Delegated Report		Analysis sheet		Expiry Date:	19/07/2021
		N/A		Consultation Expiry Date:	20/06/2021
Officer			Application Number(s)		
Josh Lawlor			2021/0602/P		
Application Address			Drawing Numbers		
Car Parking Space r/o 10 - 12 Camden High Street London NW1 0JH			See decision notice		
PO 3/4	Area Team Signature	C&UD	Authorised Officer Signature		
Proposal(s)					
Erection of 2x three storey mews houses on site of existing car park					
Recommendation(s):		Refuse Planning Permission			
Application Type:		Full Planning Permission

Assessment

1. The proposed development

Figure 2. Proposed front elevation

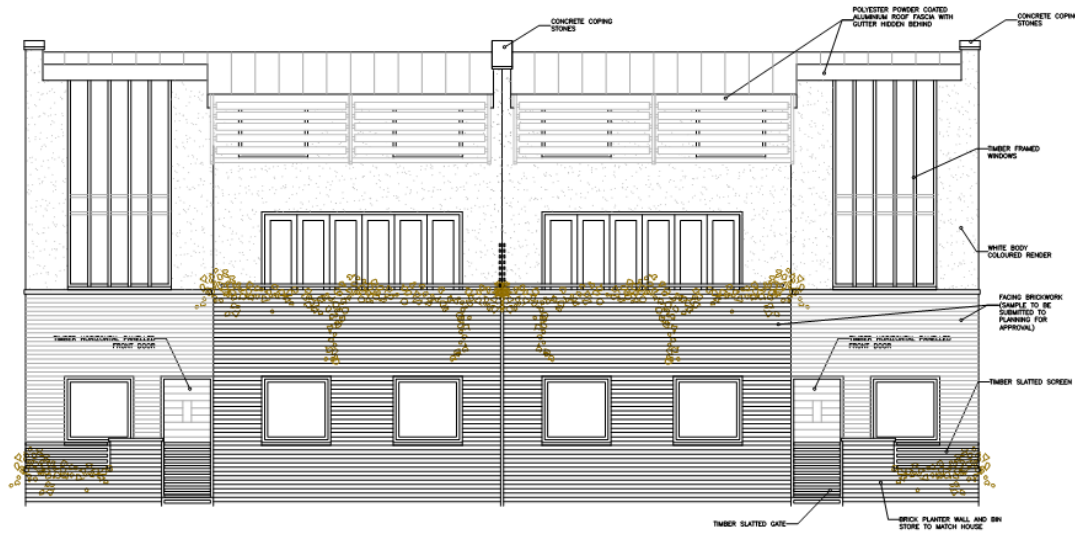
- 6.7. There is a lack of design quality and finesse to the front façade. It presents a weak and convoluted composition with a variety of window treatments with differing proportions. The volumetric set-backs and the alien roof profile results in an incoherent composition that does not reflect the local context. The use of white self-coloured render along with a PPC brise soleil is not considered to represent high quality design even if a high quality handmade brick with suitable pointing is proposed to be used on the ground storey. The brise soleil would be visible in profile from Kings Terrace which is considered to cause a negative impact to the character of the mews. The houses would appear highly incongruous within the mews context and make no reference to the history or architecture of this part of the conservation area.

Figure 4. 3D views showing relationship of proposed building with side elevation/windows 48-56 Bayham Place which is in commercial use

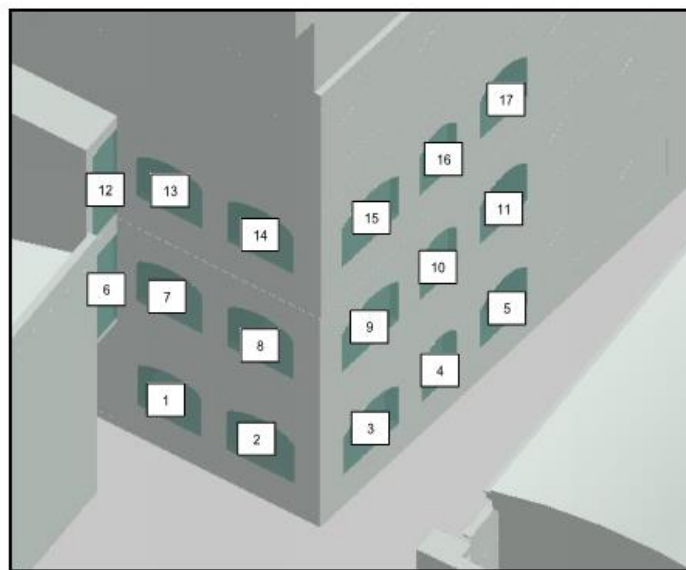
- 7.5. The daylight and sunlight report has assessed commercial windows at 48 to 56 Bayham Place. Typically the results for commercial windows are not assessed by the council. However it is noted that of the side facing windows shown on Figures 4 and 5 would experience an appreciable loss of light. All windows side windows facing the site (1, 2, 8, 6, 12, 13 and 14) would be below 27% and experience reductions greater than 20% of their former value. A number of these windows already have low levels of VSC (6 & 12) and therefore the absolute reductions in VSC are relatively low. Windows 2, 8 and 14 serve open plan, dual aspect rooms, with the secondary windows on the south west elevation. The windows on the south west elevation are largely unaffected in terms of VSC. Windows 1 and 7 are single aspect rooms which look over the application site. The impact to these windows is considered acceptable as these are 'unneighbourly' in that they face directly over the application site and are in commercial use.

Figure 6. Plan view showing relationship with Kings Terrace to north

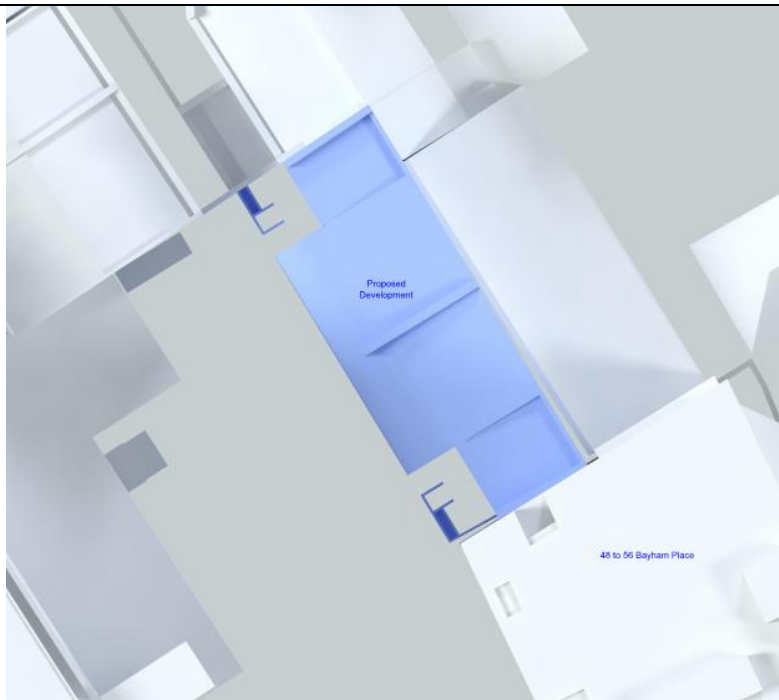
7.6. In terms of the residential amenity impact to southernmost point of Kings Terrace, the building protrudes no more than the front building line of existing terrace at the boundary wall. At the ground floor the boundary wall is continuous with no residential windows. There is no need for the daylight and sunlight to assess windows on Kings Terrace as there would be no impact.
